**S2.1.1**

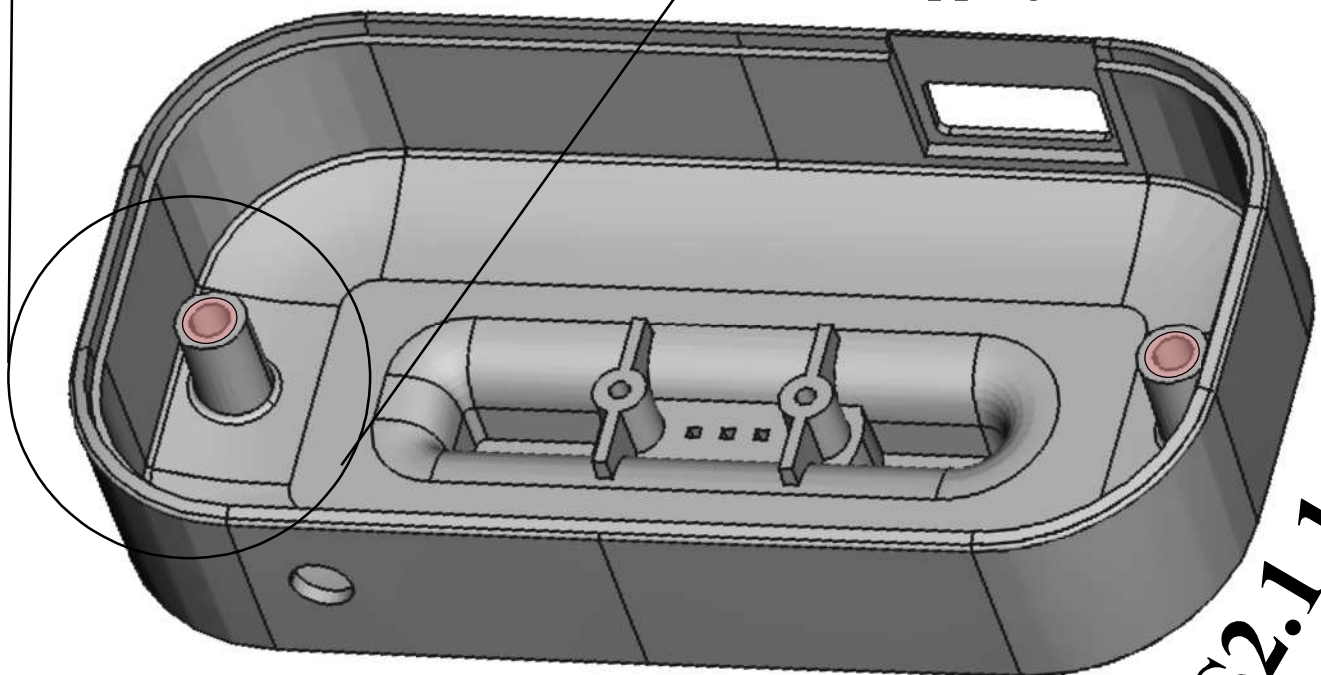
Reduce inserts in all  
screw hole bosses to  
2.2mm diameter (for  
smaller M2.5 self-  
tapping screw)
